Document
Design & Access Statement Addendum

Project
Sunte House

Sunte House: Householder Planning Application DM/25/1705; DM/25/1706 Design and Access Statement Addendum December 2025

1.3 The Dairy Plan Adjustments

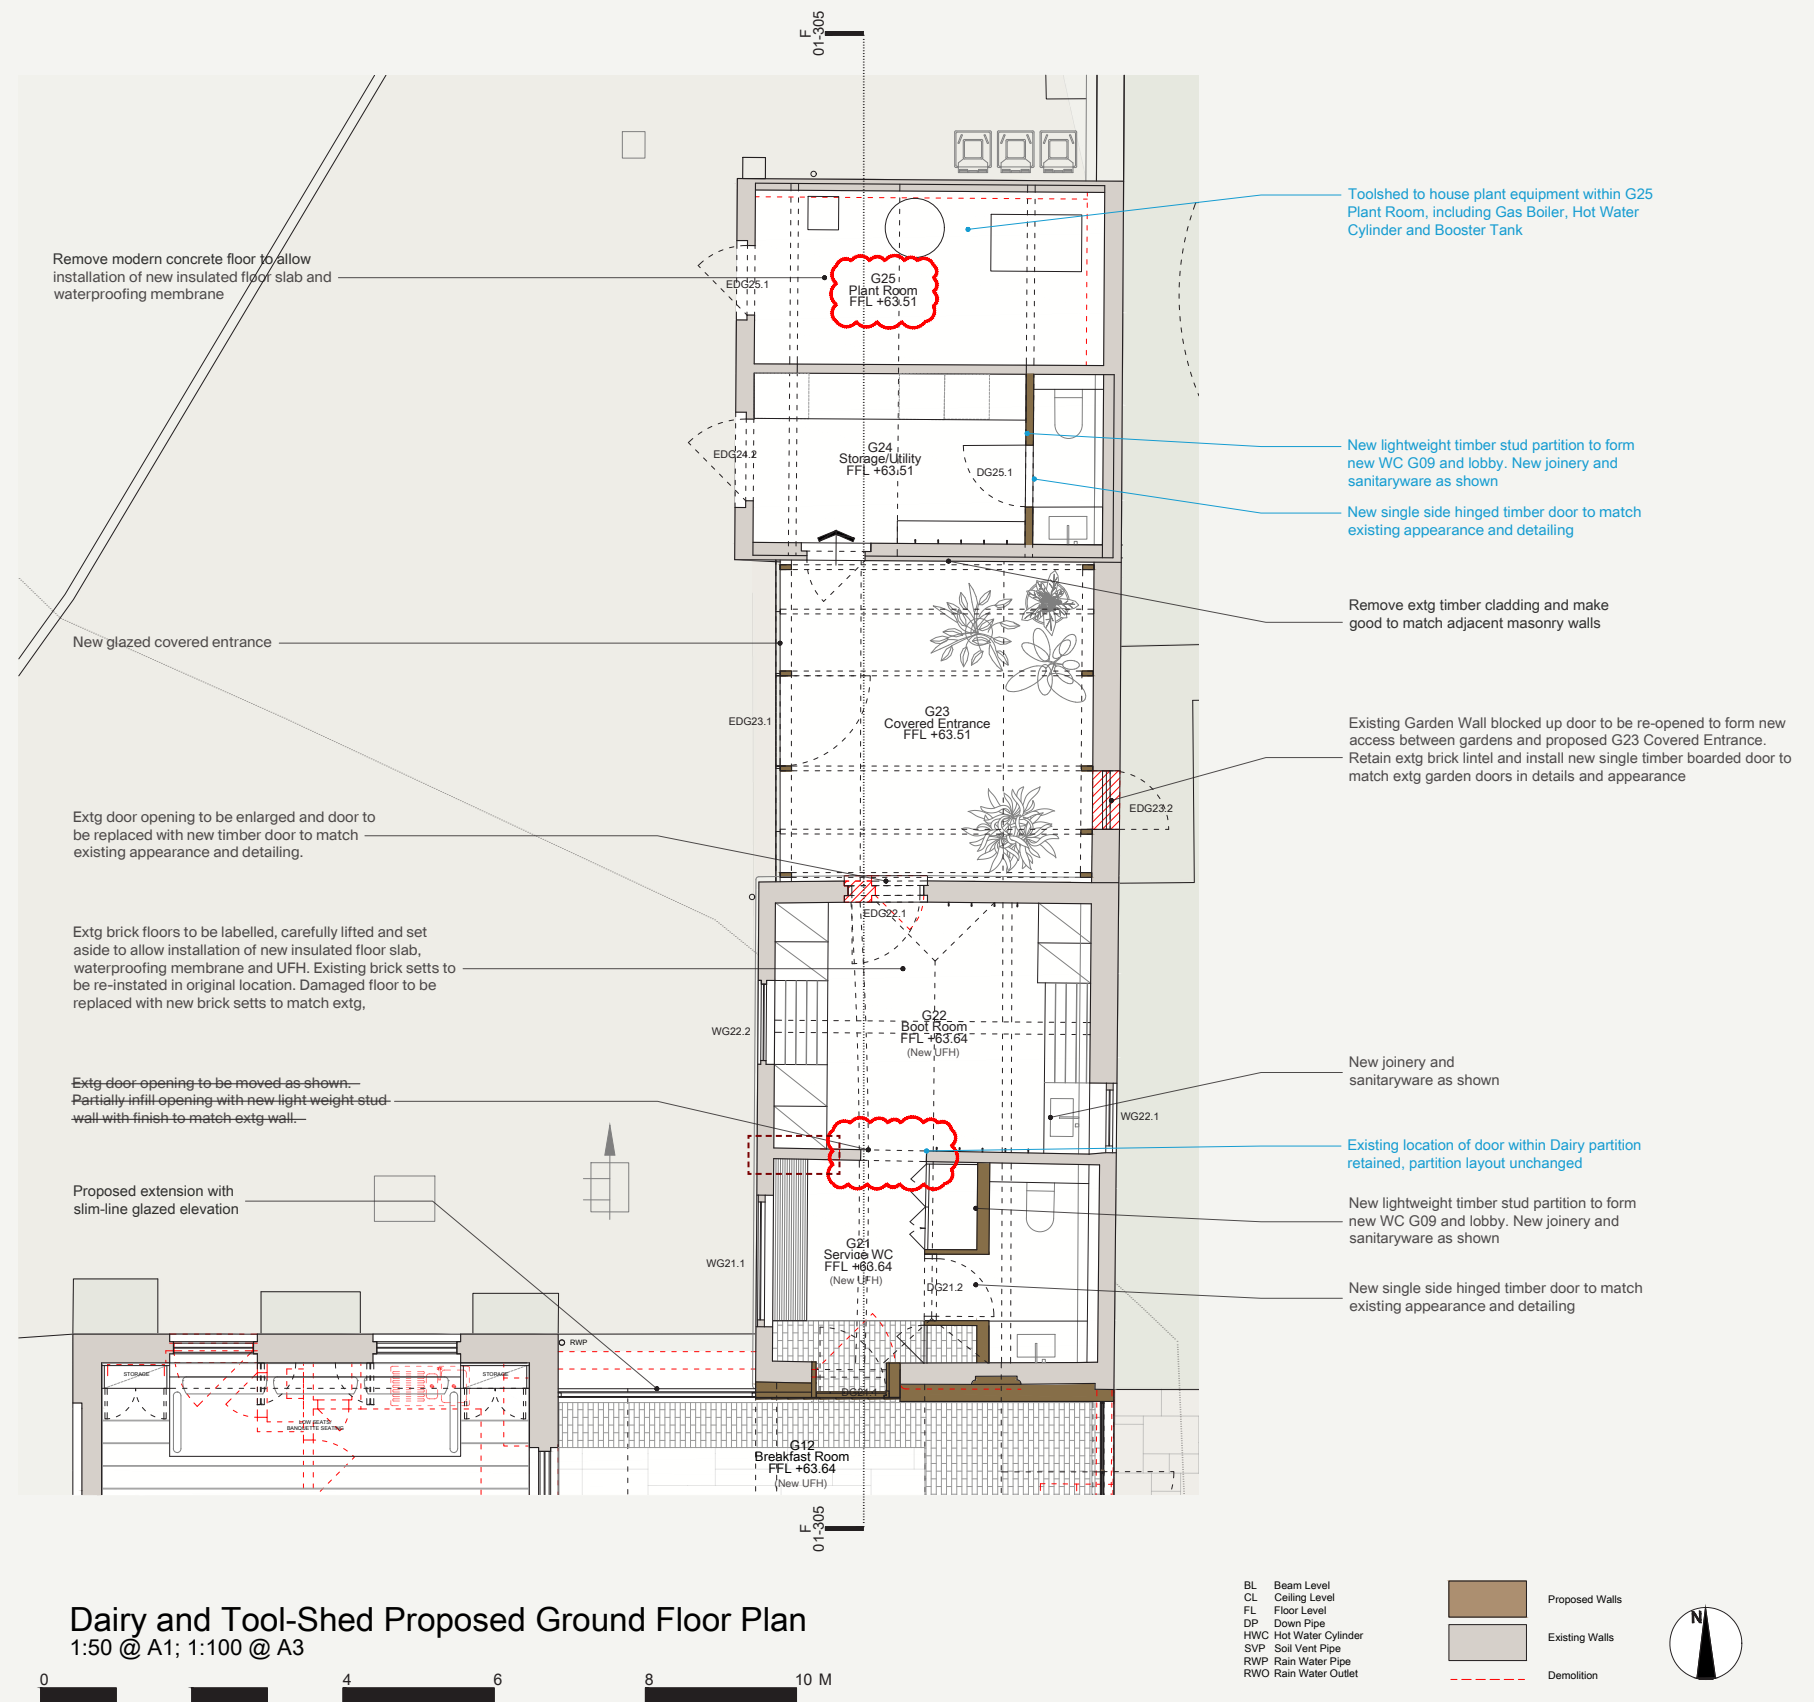
Officer Concerns

- Retain existing internal door and wall
- Reduce extent of new subdivision.
- Keep original plan form legible

Design Review

- The design has been refined to maintain the door at its original location in the partition wall.
- Proposed cabinetry and new partition will not be full height to ensure the spatial volume and plan form is legible

1.5 Pool House: Planning Submitted Design (June '25)

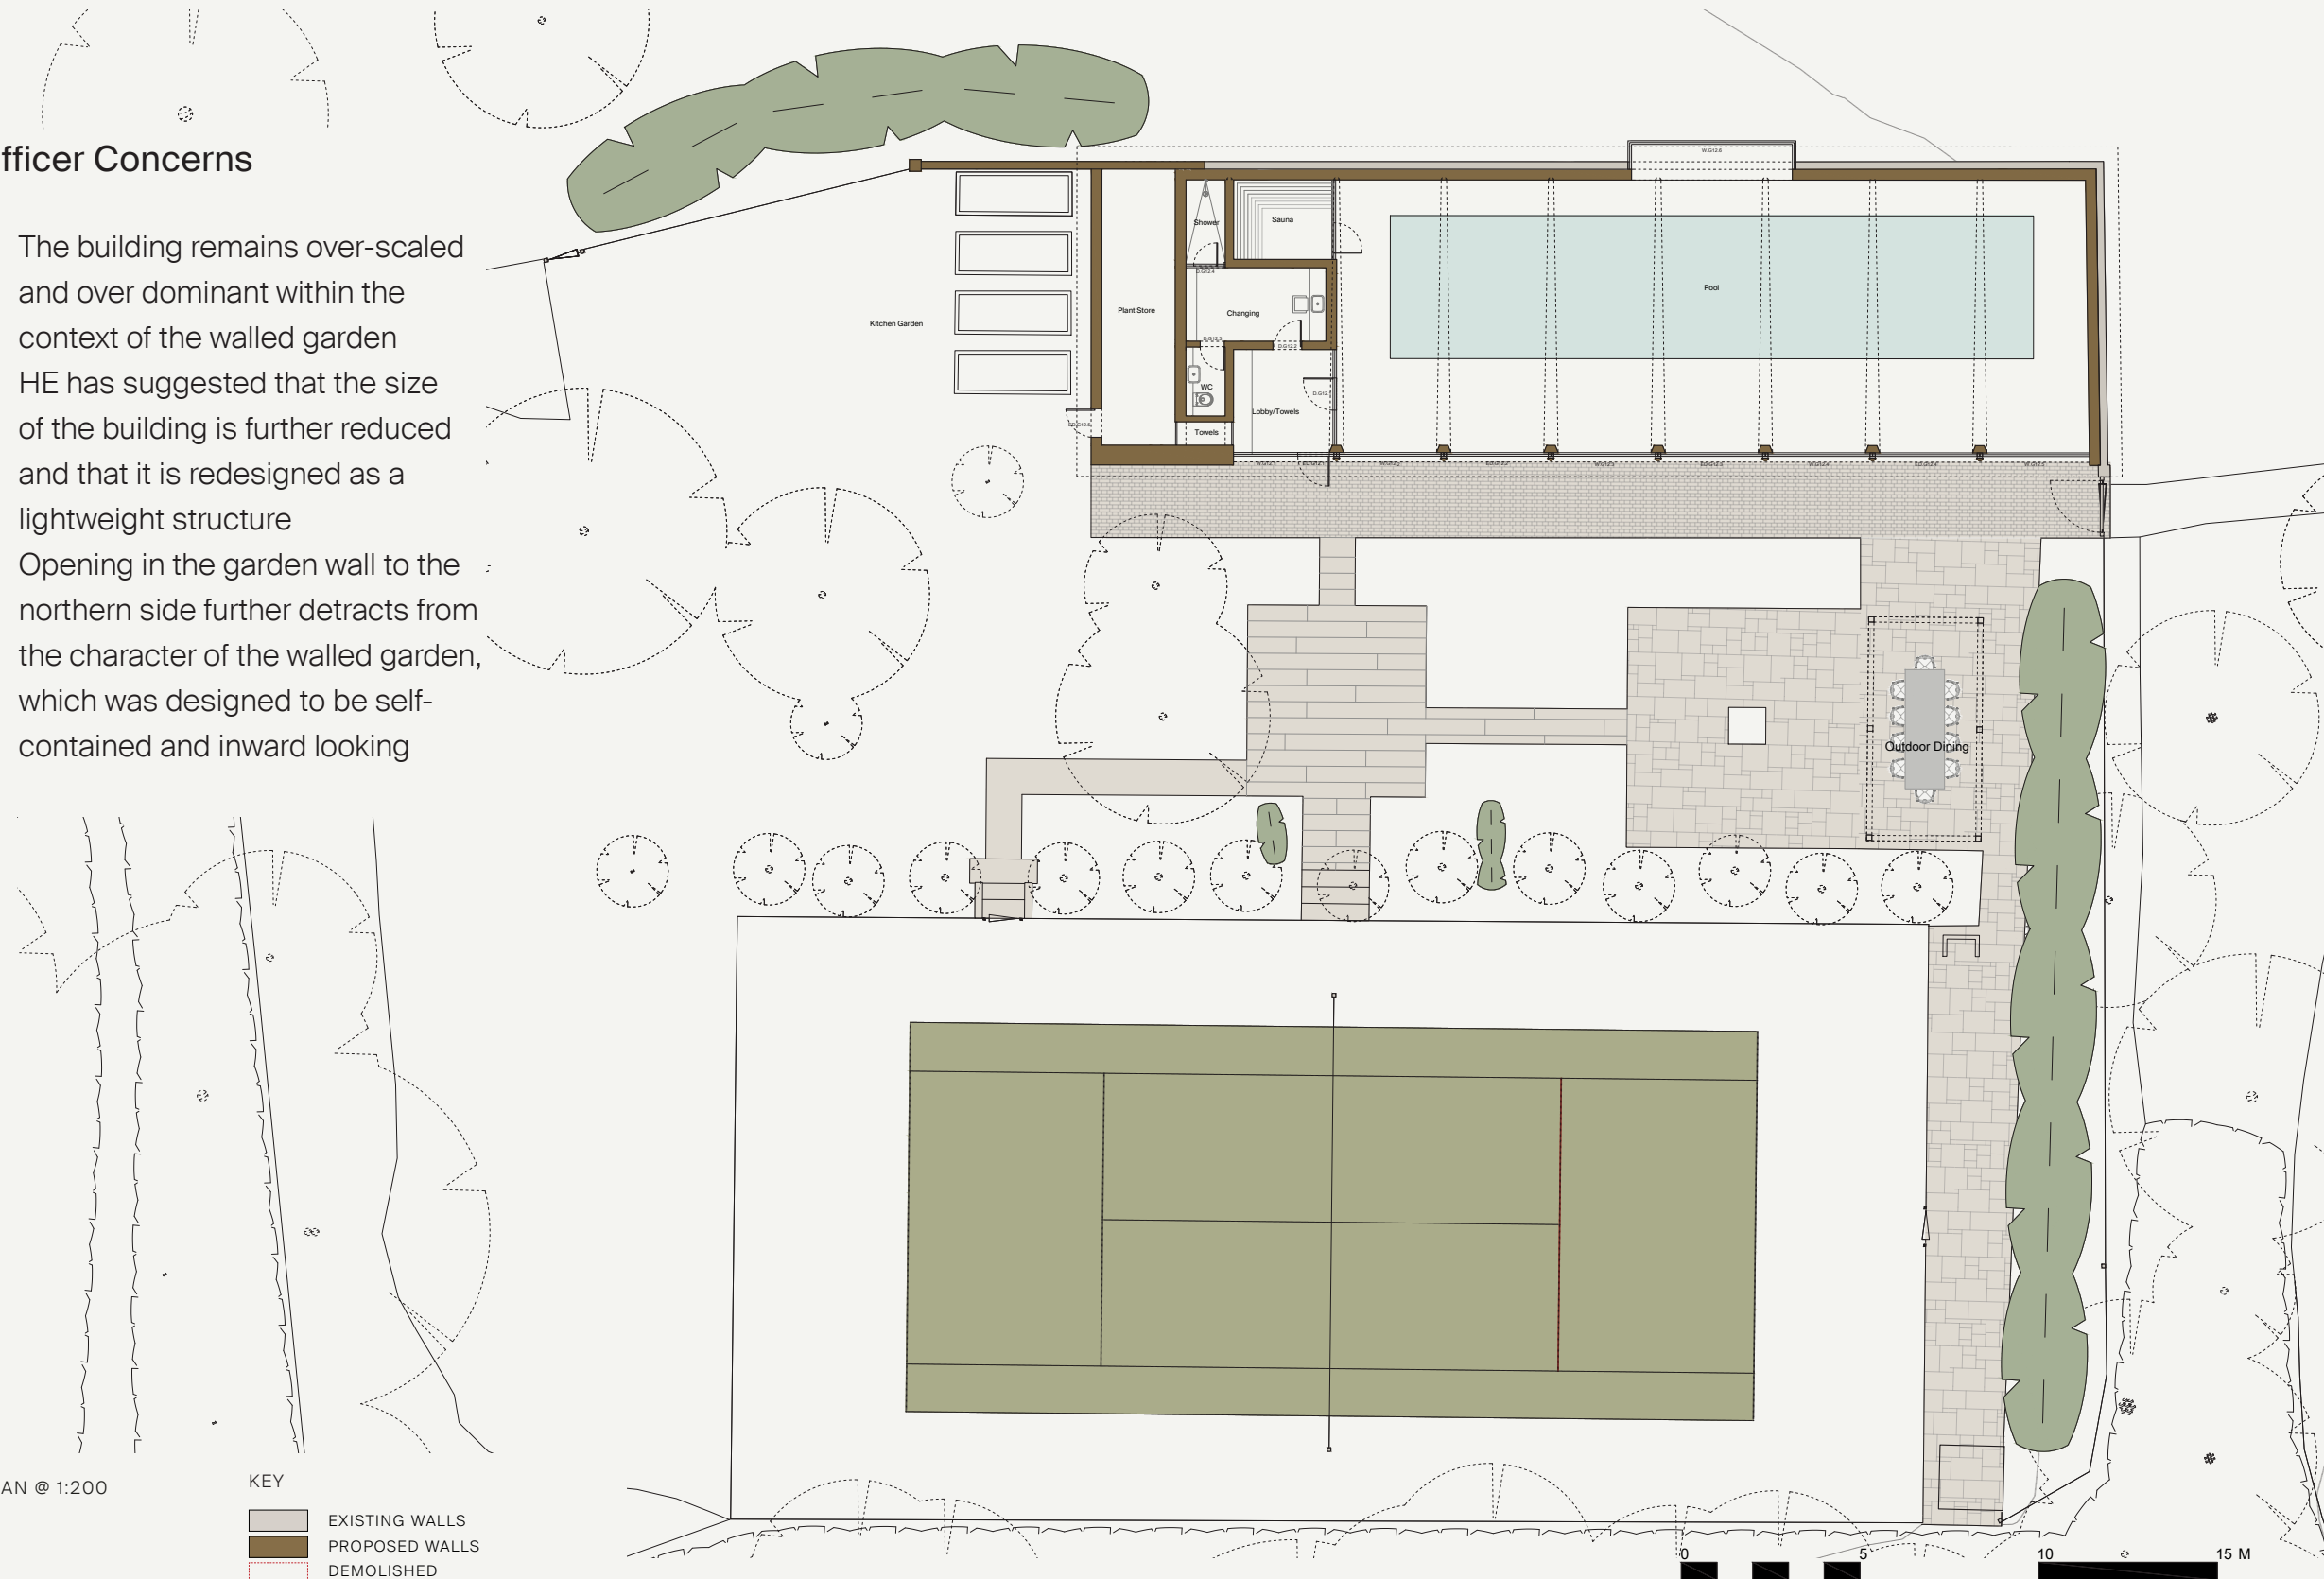
Officer Concerns

- The building remains over-scaled and over dominant within the context of the walled garden
- HE has suggested that the size of the building is further reduced and that it is redesigned as a lightweight structure
- Opening in the garden wall to the northern side further detracts from the character of the walled garden, which was designed to be self-contained and inward looking

EYE LEVEL SKETCH OF THE POOL HOUSE AS SEEN FROM THE TENNIS COURT

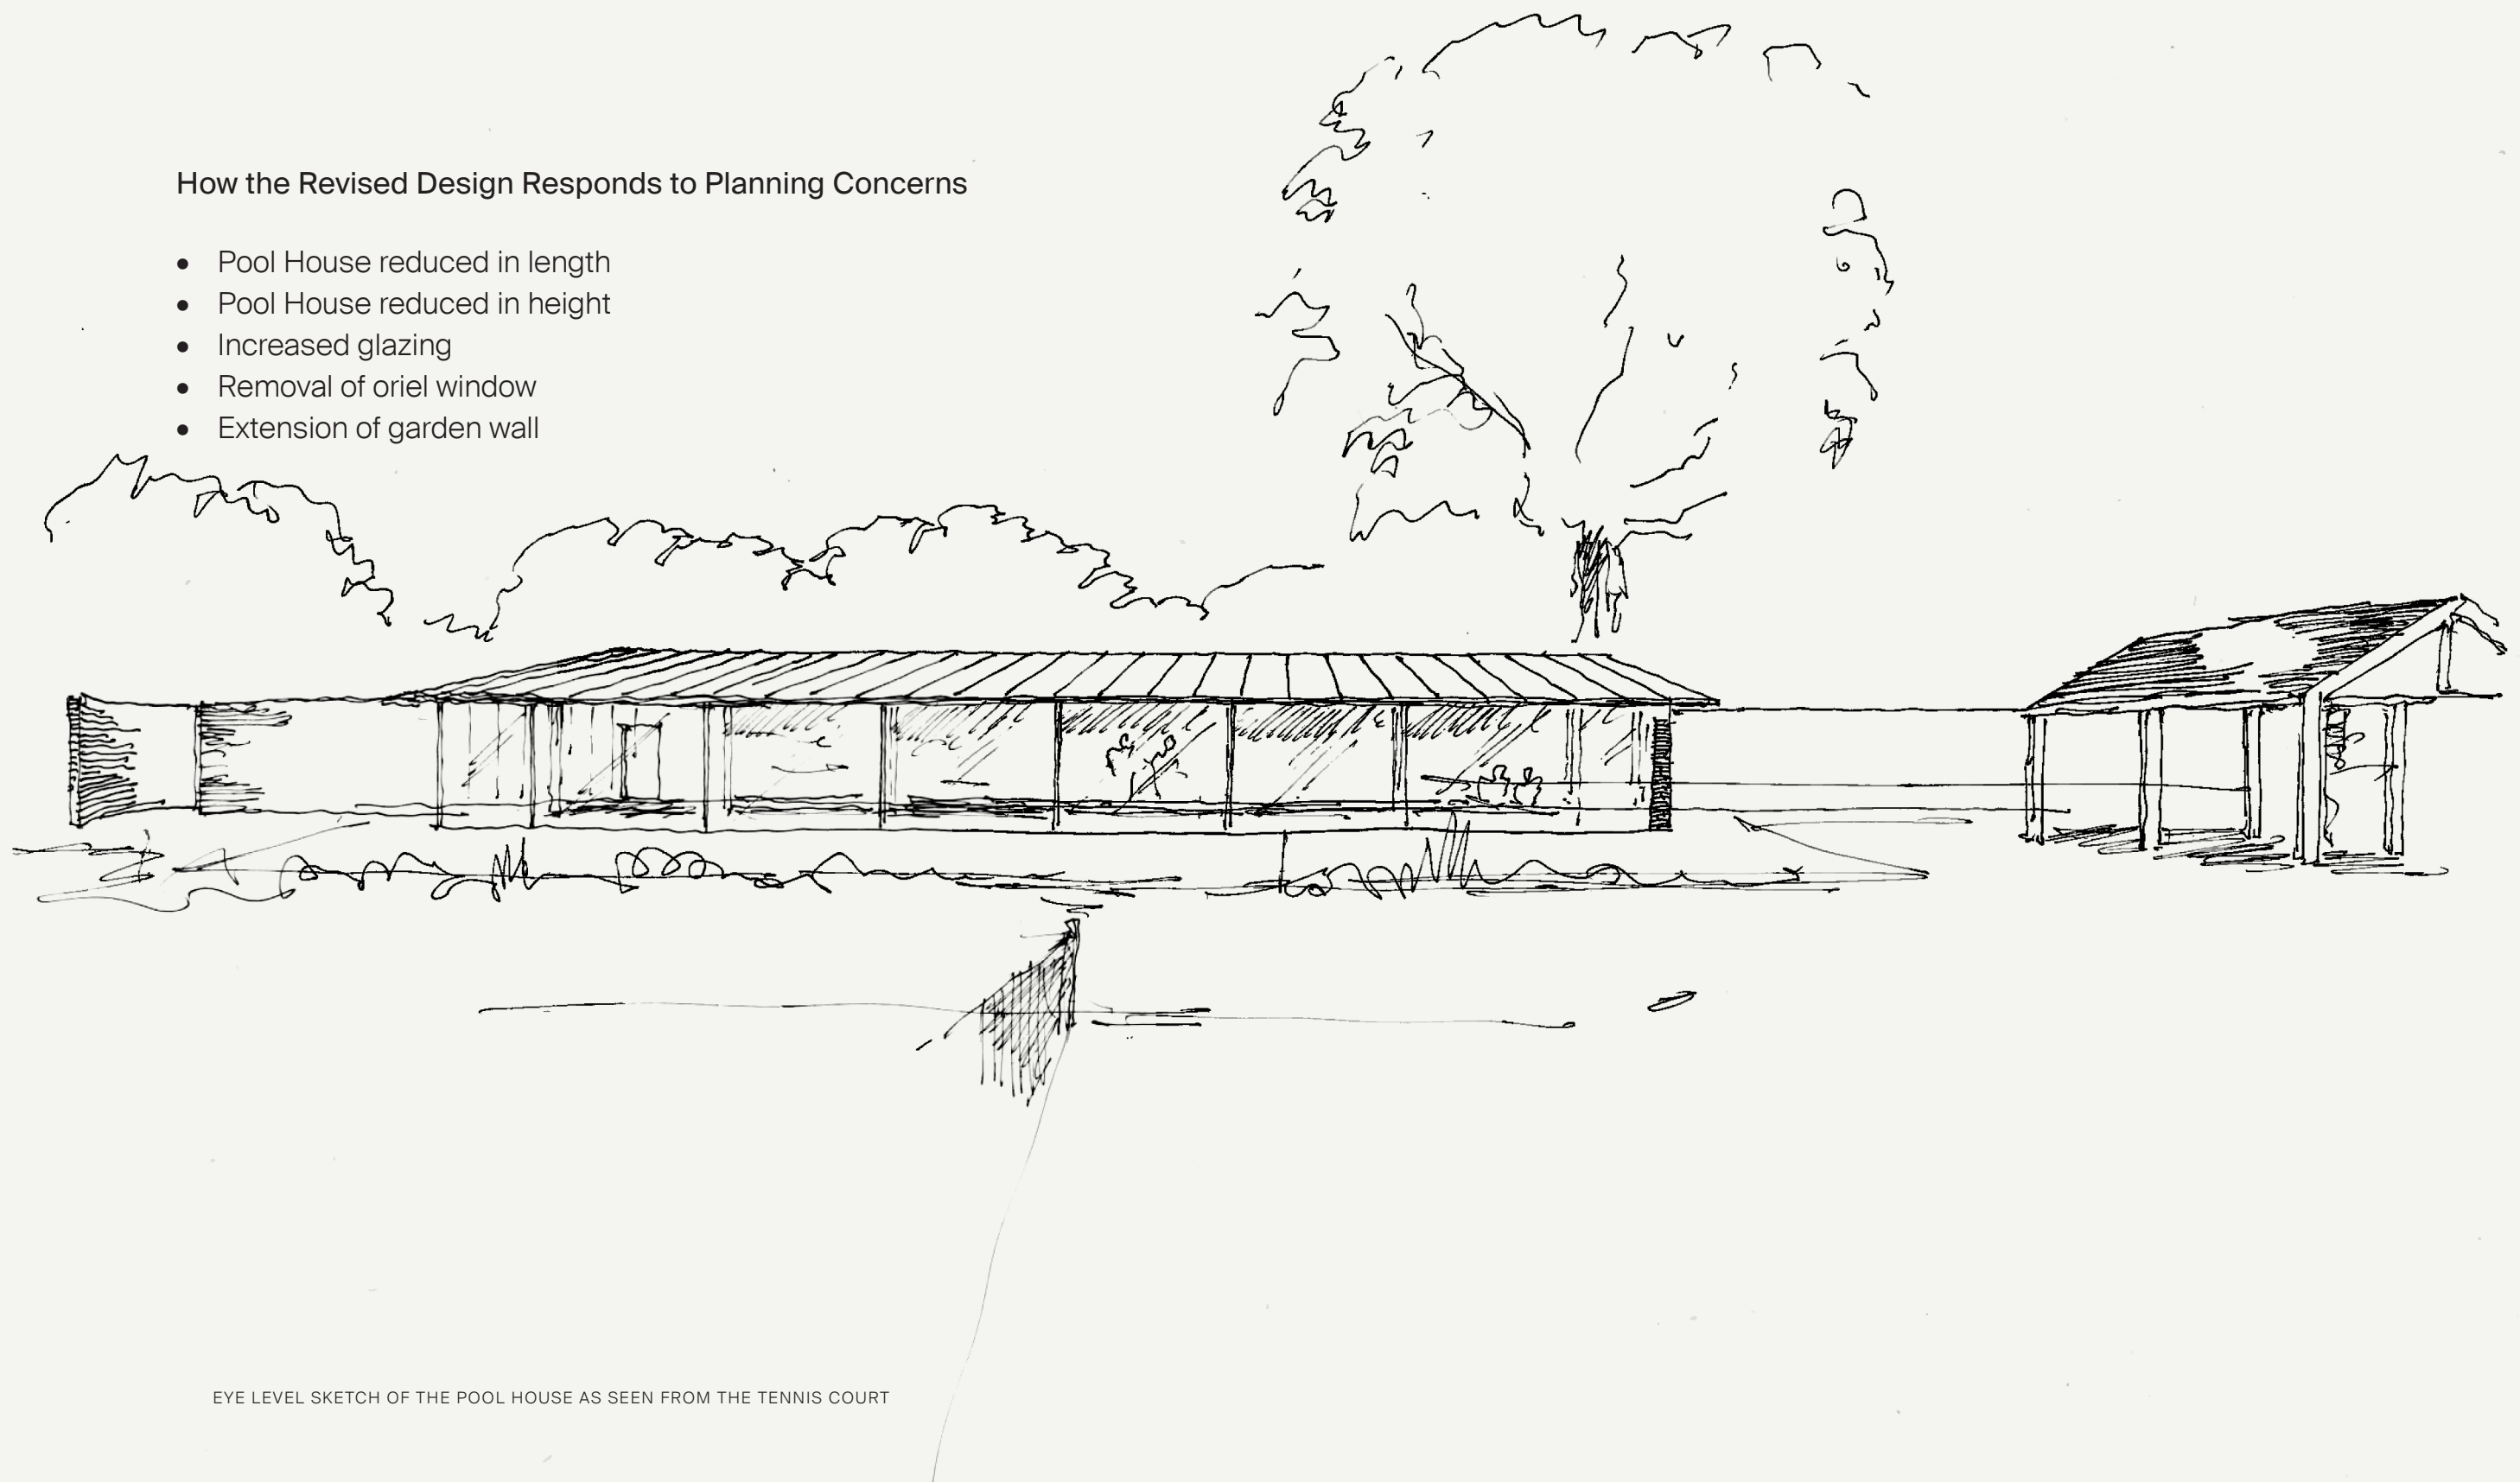
How the Revised Design Responds to Planning Concerns

- Pool House reduced in length
- Pool House reduced in height
- Increased glazing
- Removal of oriel window
- Extension of garden wall
